# Difference $R_{\text{peak}}$

Comments #303, #350, #351

Adee Ran, Cisco

# Purpose: addressing these TBDs

Figure 163A–2—Configuration for transmitter reference steady-state voltage, pulse peak, and ERL

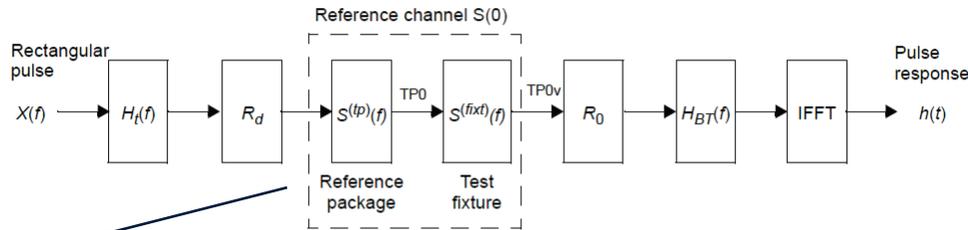
- Use  $v_{\text{peak}}^{(\text{ref})}$  and  $v_f^{(\text{ref})}$  as defined in 163A.3.1.1 with the following considerations:
  - For host output (179 and 176D), redefine the reference channel of Equation 163A-1 (Figure 163A-2) to include the partial host channel corresponding to the host class that the device adheres to

- For module output (176D), use the reference channel of Equation 163A-1 as it is; use the higher-loss package model (case 2, 10 mm trace)
  - For  $S^{(\text{fixt})}$ , use “mated test fixtures measured according to 178A.1.3” instead of the “Measured Tp0 to TP0v”
